Project	IEEE 802.16 Broadband Wireless Access Working Group < http://ieee802.org/16 >	
Title	QoS management Primitives for Service flow management	
Date Submitted	2005-07-19	
Source(s)	Jung Mo Moon	myyun@etri.re.kr
	Mi Young Yun	jmmoon@etri.re.kr
	Sang Ho Lee	leesh@etri.re.kr
	ETRI	Voice: 82-42-860-5587
	161, Gajeong-dong, Yuseong-Gu,	Fax: 82-42-861-1966
	Daejeon, 305-350, Korea	
Re:	Contribution on comments to IEEE 802.16g-04/03r3	
Abstract	In this contribution, we propose to define some primitives for QoS management.	
Purpose	Adoption	
Notice	This document has been prepared to assist IEEE 802.16. It is offered as a basis for discussion and is not binding on the contributing individual(s) or organization(s). The material in this document is subject to change in form and content after further study. The contributor(s) reserve(s) the right to add, amend or withdraw material contained herein.	
Release	The contributor grants a free, irrevocable license to the IEEE to incorporate text contained in this contribution, and any modifications thereof, in the creation of an IEEE Standards publication; to copyright in the IEEE's name any IEEE Standards publication even though it may include p

Figure XX1. An example of QoS mapping between a BS and a NCMS in case of MSS-initiated service creation

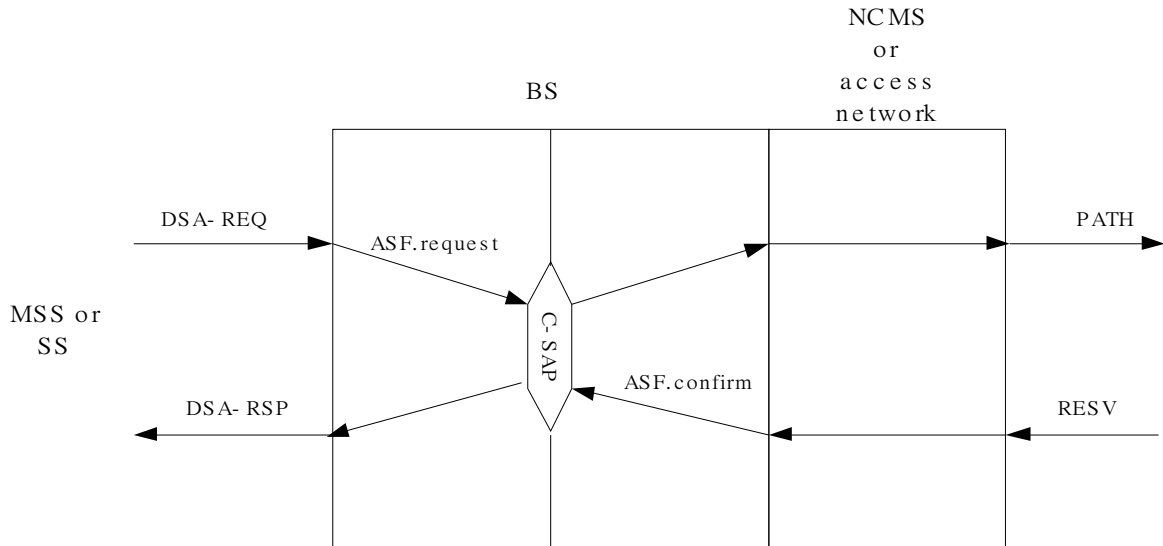
Figure XX1, XX2 and XX3 show an example of QoS mapping between a BS and a NCMS when the RSVP in network side is applicable. Flow service messages such as DSA, DSC and DSD will be transformed into “PATH” and “RESV” in RSVP messages [1] [2]. Service flow information such as delay, minimum traffic rate and so on are mapped to “flow spec” in RSVP. CS parameter information such as IP addresses, ports and so on are mapped to “filter spec” in RSVP.
